Service Bulletin

Affects: All QC-760X change machines using a Topway LM32019EFW blue graphical display.

Description: Topway LM32019EFW **blue graphical display** is now End of Life.

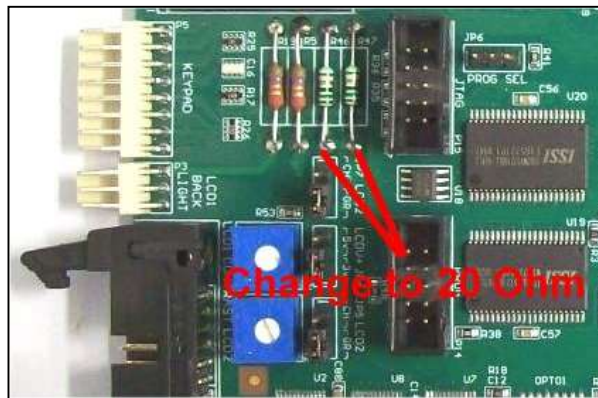
Topway **LM32019ECW-1**, Anztec pn. **50-000301**, will become the default display. This display is black text on a white background.

As the backlight current requirements are different for the new display the current limiting resistors on the EVO 700-10X board must be changed to accommodate this.

LM32019ECW-1 also has no contrast adjustment so potentiometer VR2 will be rendered obsolete.

Failure to change the resistor values will allow too much current to flow into the backlight and shorten its lifespan possibly permanently damaging or destroying it completely in a short space of time.

Change resistors R46 and R47 on the 700-10X board from 15 Ohms to 20 Ohms 0.5W
